**Shenzhen DO Intelligent Technology Co., Ltd**

Ref: FCC Class II Permissive change for FCC ID: 2AHFT537

This is to request a Class II Permissive change for FCC ID: 2AHFT537 originally granted on 12/28/2023 (date).

**GTX15**

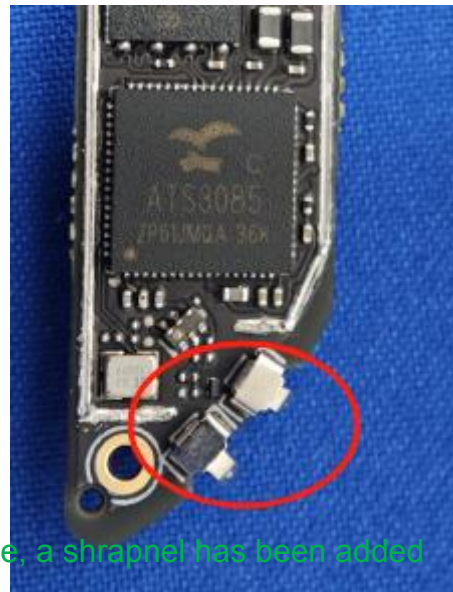
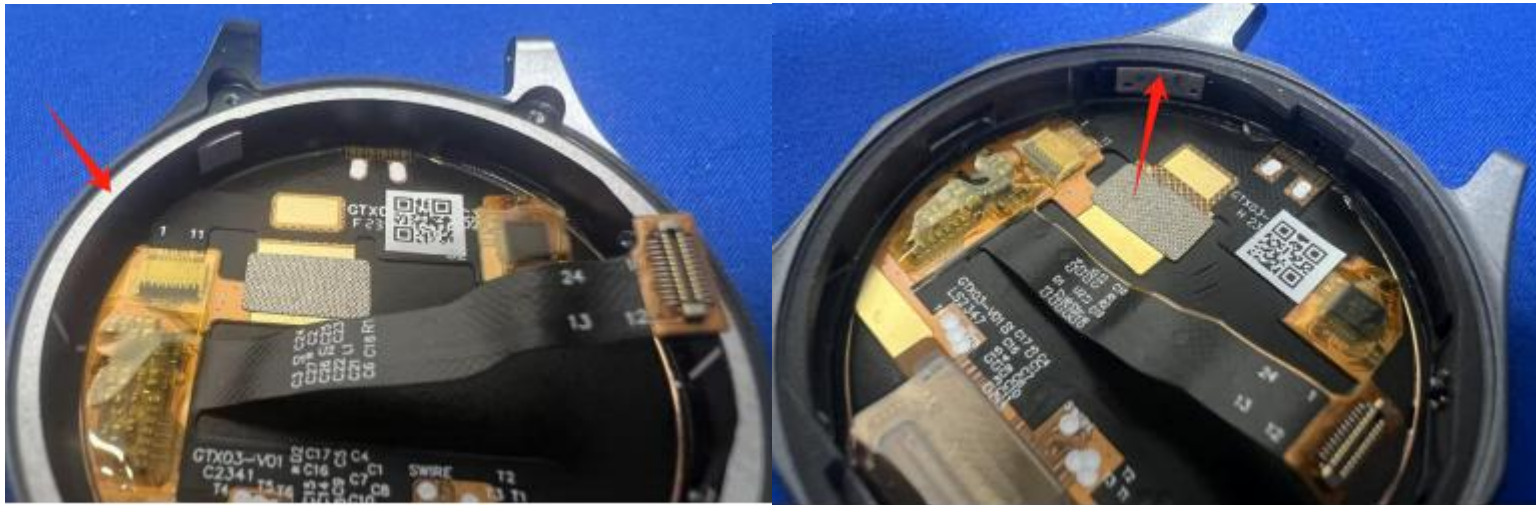
Antenna type: changed from metal frame antenna to LDS antenna

Antenna gain: changed from -2.74dBi to -2.1dBi

Because of the change in antenna type, a shrapnel has been added
